SNS-OPM-ATT 2.B-10.a.
Unreviewed Safety Issue (USI) Evaluation Form

USI Evaluation for Modifications to Beam Line 16B VISION Secondary Shutter Deceleration Switches.

Figure 1. Existing Switch Arrangement Showing the Redundant OPEN PPS and Lower Deceleration Switch (Note that the mounting bracket for the “down” position deceleration switch has been deformed due to improper alignment causing improper operation of the switch.)

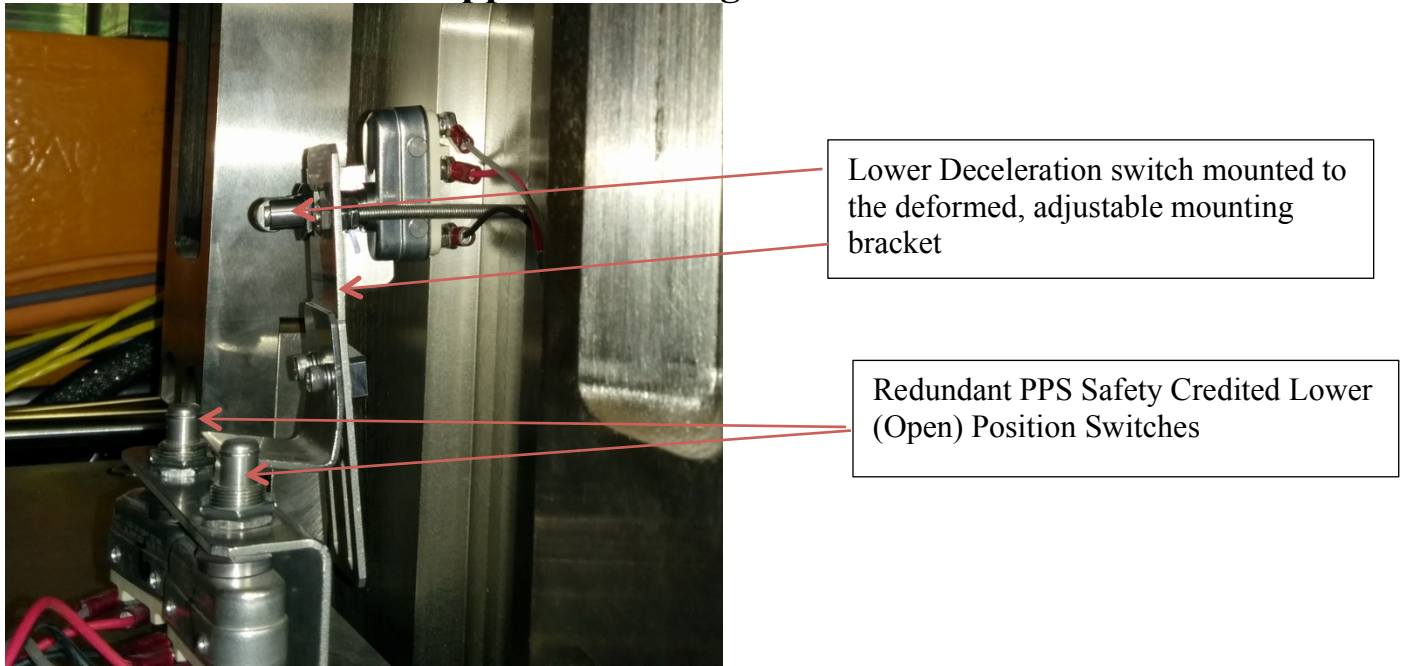
The existing mounting arrangement has been operationally problematic, very difficult to service and has caused significant instrument downtime. Alignment of the deceleration switches is difficult and slight misalignment can lead to the deceleration switches being damaged by the secondary shutter movable block. Figure 1 shows the lower deceleration switch and shows some bending of the mounting bracket that has been caused by slight misalignment. The proposed modifications are designed to provide a more robust and reliable switch arrangement that will additionally be more convenient to service.

The deceleration switches are presently mounted inside of the secondary shutter cavity in close proximity to the redundant PPS Open and Close position switches that provide the credited safety function as shown in Figures 1 and 2. Figure 1 show the lower deceleration position switch and the lower redundant PPS Open position switches that provide the credited safety function. Figure 2 shows the upper switches. As the shutter moves from the up to down position, it first contacts the deceleration switch, sending a signal to the PPS controller to slow the rate of travel. When the shutter is in the down (Open) position, it sits on and depresses the redundant PPS credited safety position switches.

It is proposed to remove the existing deceleration switches (Honeywell Model 3HT1) and their mounting brackets and to replace the switches with Honeywell GL Series Model GLAA07A1B switches mounted to on the side of the secondary shutter cavity as shown in Figure 4. Mounting the deceleration switches on the side of the shutter cavity will allow for ease of access and adjustment and the new type of switch is appropriate for the side mounting configuration and will be not require as precise alignment as the existing switches due to the design of the actuating arm.

Figure 2. Existing Switch Arrangement Showing the Redundant CLOSED PPS and Lower Deceleration Switch

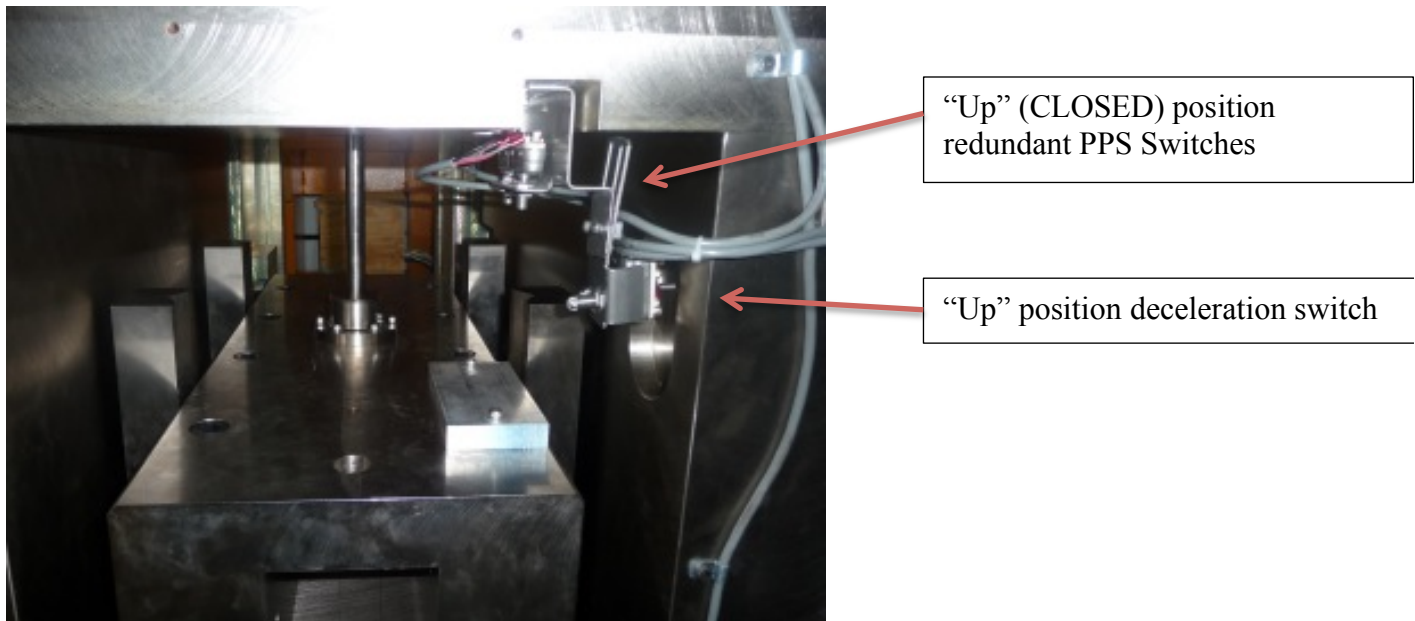
It should be noted that the redundant PPS Open and Close position switches that provide the credited safety functionality are firmly mounted in a vertical orientation (see Figures 1 and 2) within the secondary shutter cavity housing and are not susceptible to similar dres as has been experienced with the deceleration switches which were mounted horizontally on the interior mounting bracket.
